Thomsons Lake Urban Structure Study and South Jandakot Development Water Resources Management Plan

Ministerial Condition 2

Report and Recommendations
of the
Environmental Protection Authority

Environmental Protection Authority
Perth, Western Australia
Bulletin 388 May 1989

Figure 3. Proposed Urban Drainage System.

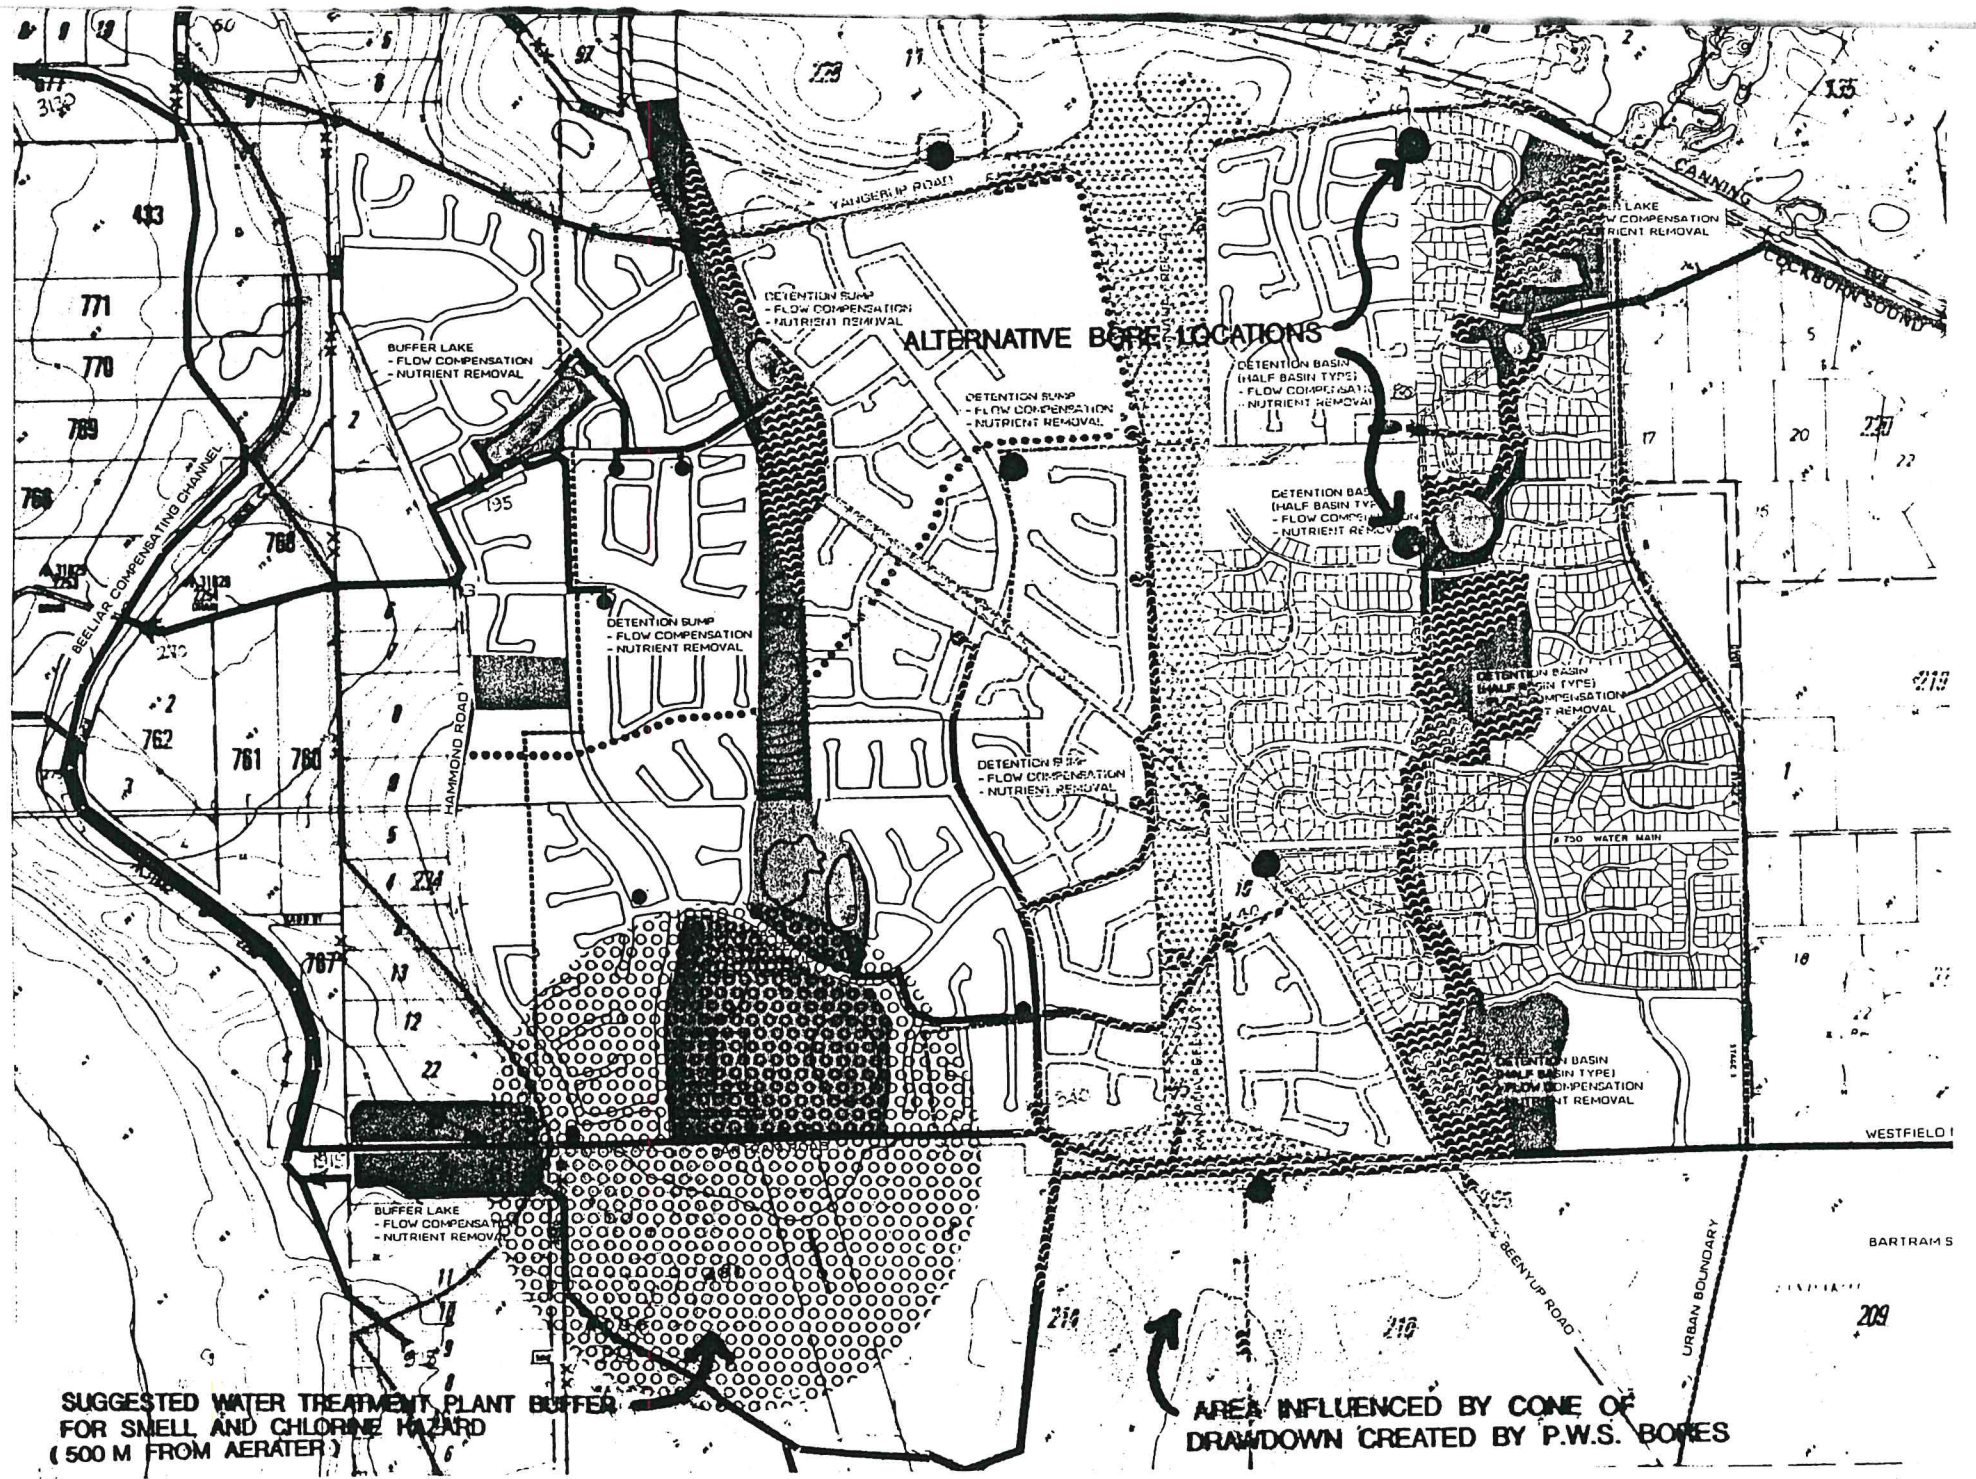
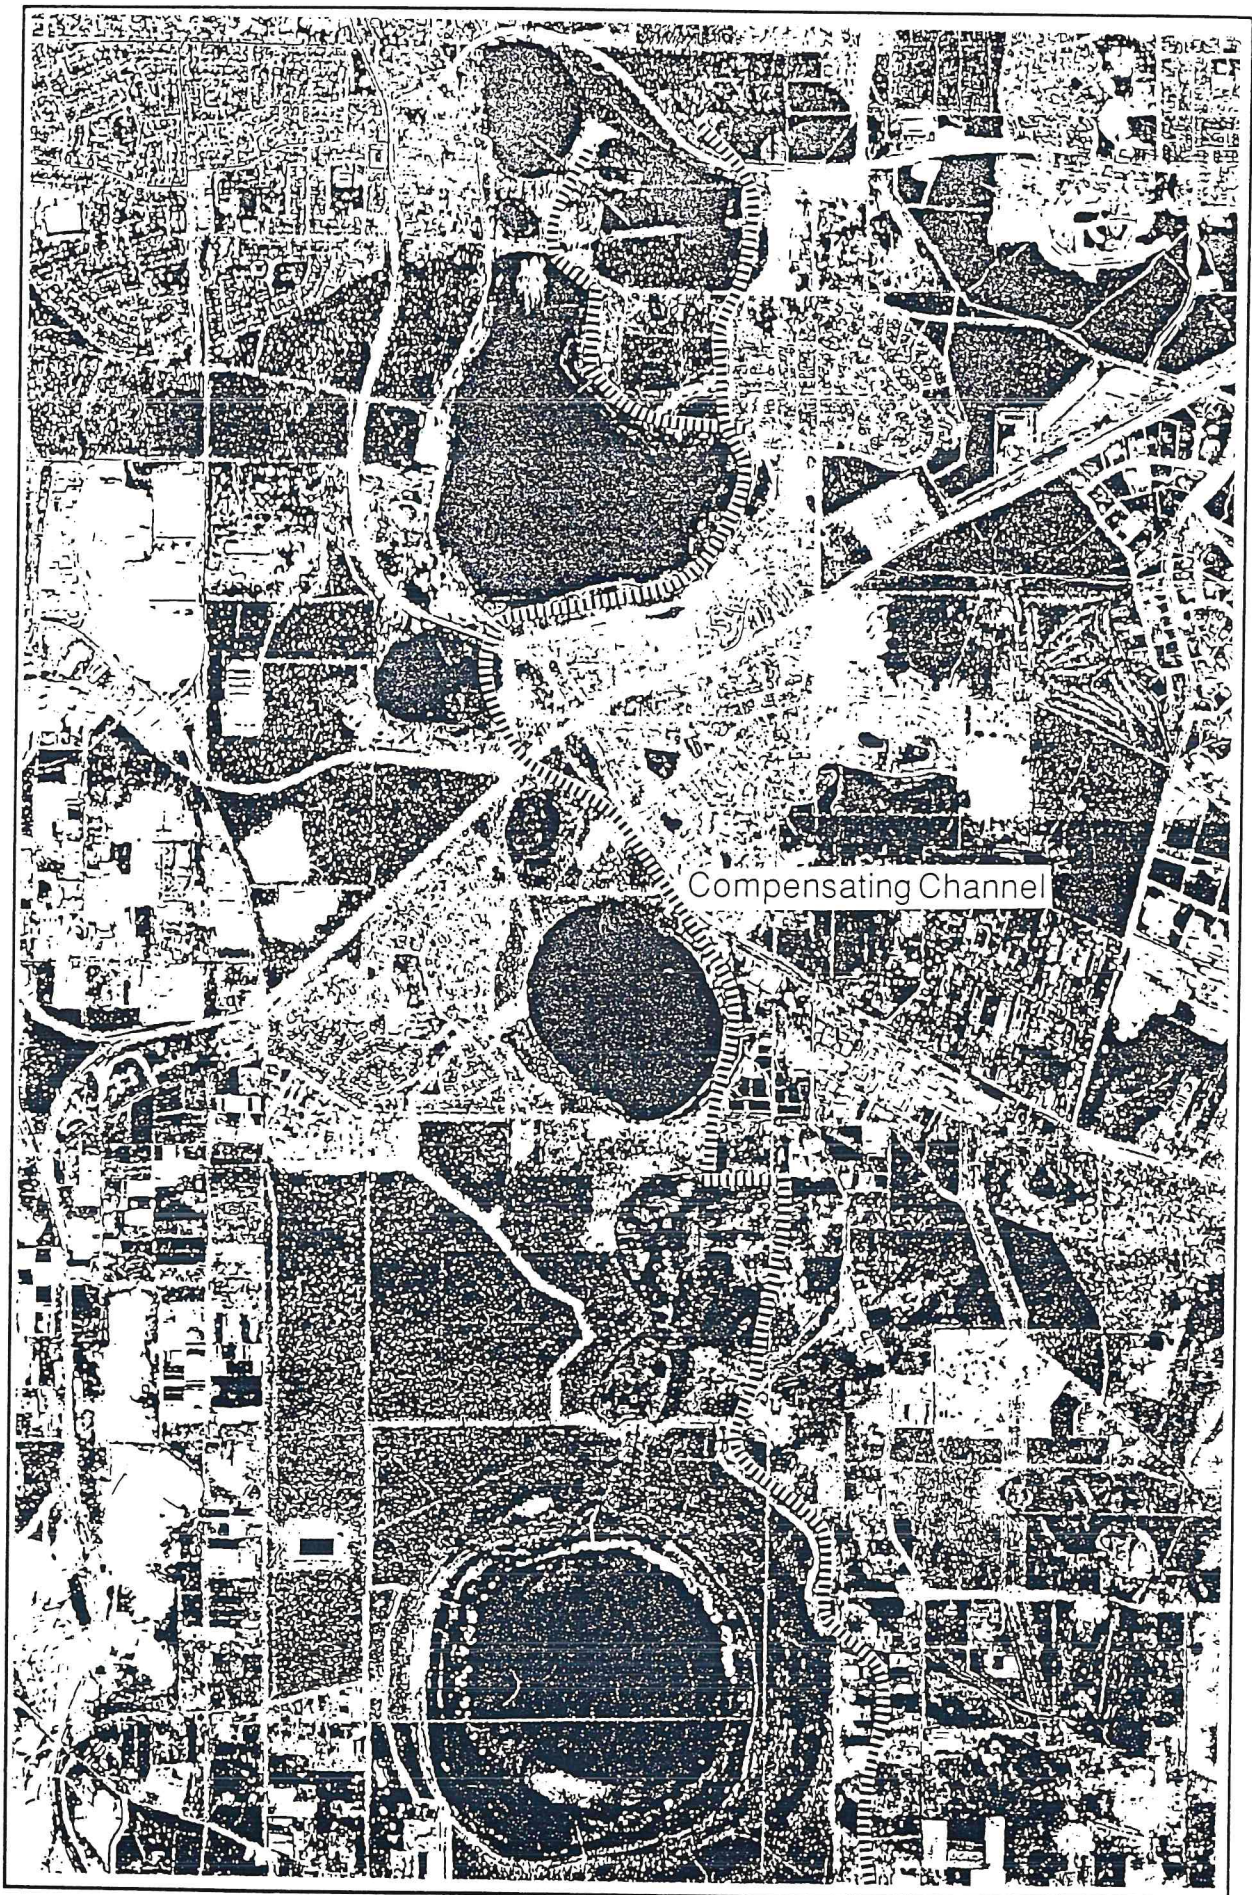
Some government Departments believed the management plan was inadequate and seven submissions indicated the proposal was vague. For example the locations of the compensating basins are not shown on maps or discussed, may not work effectively and may therefore be unable to protect the Beeliar wetlands.

The vagueness of the report made it difficult for the public and government authorities to comment on the proposal. Certain apparent inadequacies in the proposal including the following:

13. The impact and cost of post-development management need to be addressed.
14. More accurate details on the alignment of the channel are needed. Suggestions are made in the submissions that the alignment needs to be moved in some areas to avoid environmentally valuable areas, homes and factories. It was considered that consideration should be given to acquiring land rather than obtaining easements over land (page 8).
15. Clarification is required as to how the channel will assist in reducing the midge and mosquito problem.
16. There needs to be a clear indication that the drainage system will operate effectively in wet years.
17. More information needs to be provided about the impact of clearing on the proposal and surrounding areas.
18. Some submissions expressed the view that a full Environmental Review and Management Programme should have been prepared.

- 2.3 The management plan should address the hydraulic and environmental functions of both the northern and southern sections of the proposed channel. According to one submission there is a lack of evidence that the channel will function hydraulically and that the quantities of water to be transported have been accurately assessed. Another submission suggested a drainage system with a greater carrying capacity is required and two others considered that the system may not be sufficient to prevent flooding of the urban development and flow rates in the channel may be underestimated. Concern is expressed about part of the drain near Bartrum Road being below the watertable for six months each year. This conflicts with claims that wetlands near Bartrum Road may be drained by this channel. These wetland were supposed to be protected as part of the Beeliar Regional Park.

Figure 5. Cross Section Along Barttram Road.

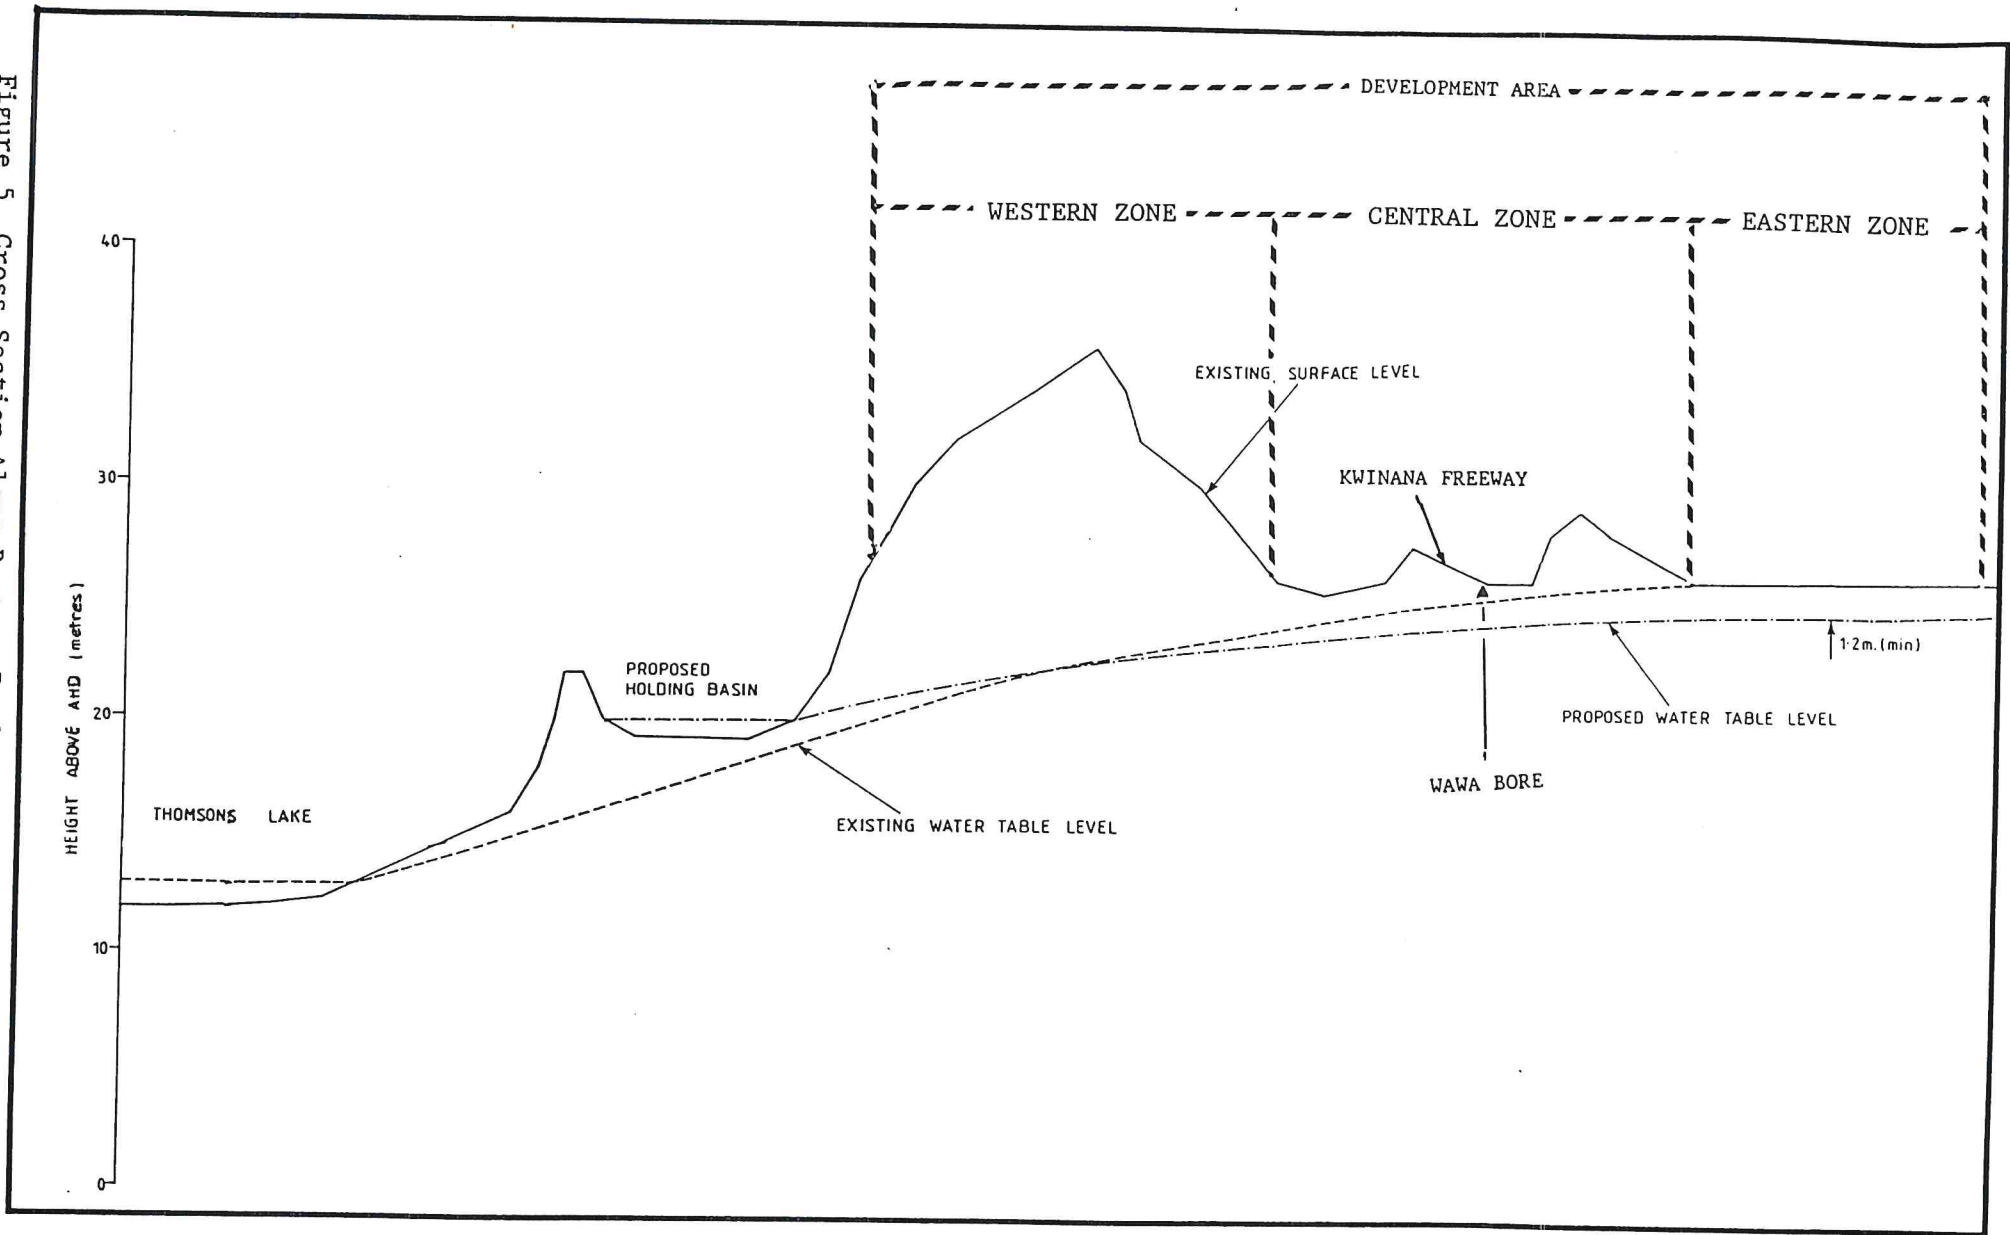
Figure 5 illustrates the existing land contours and water levels along Bartram Road, and the expected effect of urbanisation and drainage on the water levels. The approximate location of the Kwinana Freeway alignment and the proposed public water supply boreline are also indicated. Although this figure is indicative only of land contours and water levels across the

whole of the development area, it does suggest that the existing natural environment dictates a development plan which is defined by the characteristics of that environment.

Land in the eastern one third of the development area (eastern zone) is mostly swampy, is difficult to drain, would generate up to 70% of the drainage water from the entire development, would lead to most of the potential environmental impacts on the Beeliar wetland chain, would generate the major loss of water resource, and is within the recharge area which would supply the Water Authority of WA's proposed borefield. The Environmental Protection Authority now recommends that it is appropriate to exclude this area from urban development and drainage.

The Environmental Protection Authority recommends that Government does not allow residential development on the eastern one third of the development area that is difficult to develop and drain and within the main recharge area for the Jandakot groundwater mound.
